DORIS MINE

REVISIONS TO AMENDMENT APPLICATION NO. 1 OF PROJECT CERTIFICATE NO. 003 AND WATER LICENCE NO. 2AM-DOH1323: PROPONENT'S RESPONSE TO NIRB TECHNICAL COMMENTS

Responses to Technical Comments, Nunavut Impact Review Board

Figure DFO-3.2.2 – 1a. Water Withdrawal and Losses Doris Lake during Operations

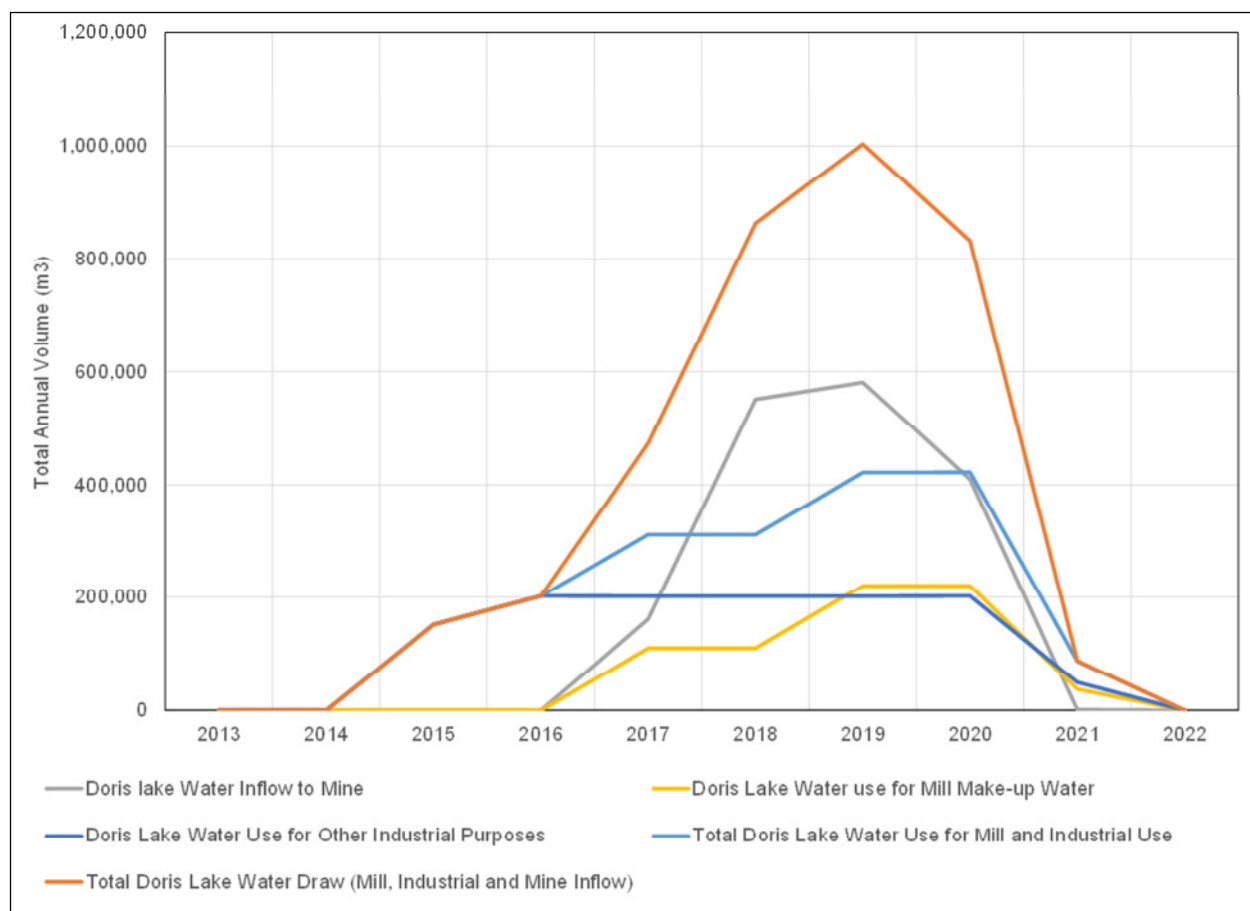
TMAC suggests that this additional loss is likely to result in serious harm to fish: "The maximum potential water level decrease due to the extraction of the currently permitted 480,000 cm³/year from Doris Lake is within the range of natural variability, and no adverse effects are predicted in the Doris North FEIS. ... The cumulative water losses from Doris lake, included the permitted withdrawal volume combined with the loss to the underground mine, are predicted to result in serious harm to fisheries and an Offset Plan and DFO Authorization will be obtained." (Package 4, p. i) [emphasis added]

The Doris North Project will use water from Doris Lake for Mill Make-up Water and other Industrial use as described in supporting document P6-10, Site-Wide Water and Load Balance Model. Figure 6-6 in Section 6.2.2 of that document graphically presents the mean Doris Lake inflows and outflows graphically. Figure DFO-3.2.2 – 1a below, plots the same information but focuses on the period of active mining, and only presents the water withdrawals components as a result of the mining activities undertaken by TMAC. This demonstrates that the peak water draw from Doris Lake as a result of mill make-up water and other industrial use is about 422,000 m³/year (blue line), and this occurs for only two years of operations.

Figure ECCC-7 - 1. Concentration of Total Dissolved Solids in 10WBW001 Zone 6

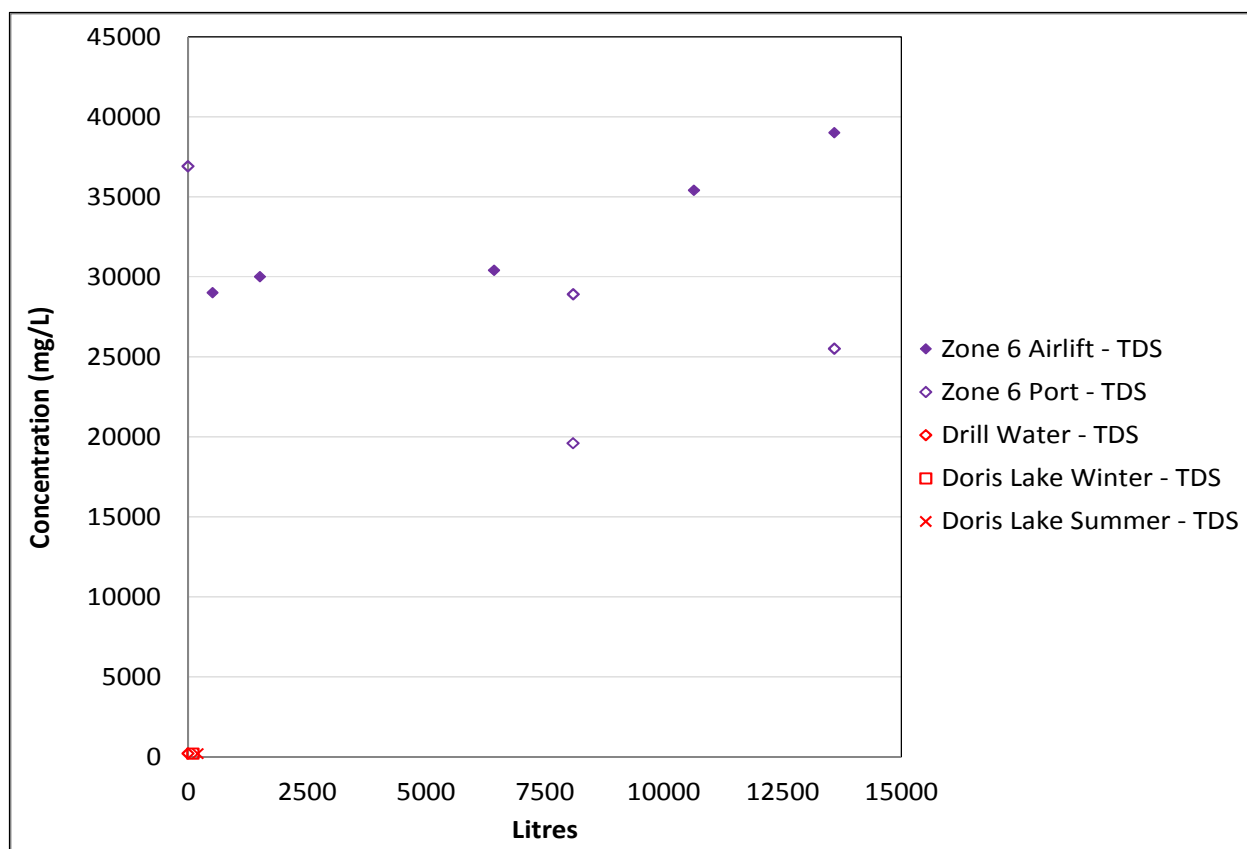
The Proponent's response to EC IR#6 states that 96 hour acute toxicity tests on 3-spine stickleback were completed in October of 2010. The test results are discussed, however, the laboratory results are not provided in the amendment application or in their response. It was also unclear whether the groundwater sample used for testing was an accurate representation of the anticipated groundwater quality that will be managed and discharged.

Recommendation/Request: Provide the laboratory reports on the ground water toxicity testing that was conducted in October of 2010. Discuss the location, depth and quality (provide chemical characterization analytical results) of the ground water sample used in the testing. Indicate what criteria were used to determine that the groundwater sample used was reflective of anticipated effluent quality. Discuss any additional testing that is proposed to assess the toxicity of "end of pipe" effluent.

The comparison of repeated samples over time indicated that variability occurs in natural concentrations of groundwater, some of which may be induced by the pumping and drawing in groundwater from locations further from the well, from the different sampling methods (airlift vs. discrete samples), and/or lab analysis methods (water vs. seawater analysis). Figure ECCC-7 - 1 shows the progressive changes in concentration of total dissolved solids (TDS) throughout the development, between 19,000 and 39,000 mg/L.

Graphs showing trends for pH, conductivity, dissolved magnesium, chloride, dissolved calcium, sulphate, dissolved sodium and total barium are provided in Appendix B: ECCC-7 - 2. Concentrations for each of these parameters, except total barium, followed a similar pattern to TDS, showing variability throughout the development, close to being stable but still increasing slightly, and all at much higher concentrations than drilling water. Barium, along with other metals, showed some difference in concentrations between airlift and port samples, making any overall concentration trends difficult to determine.
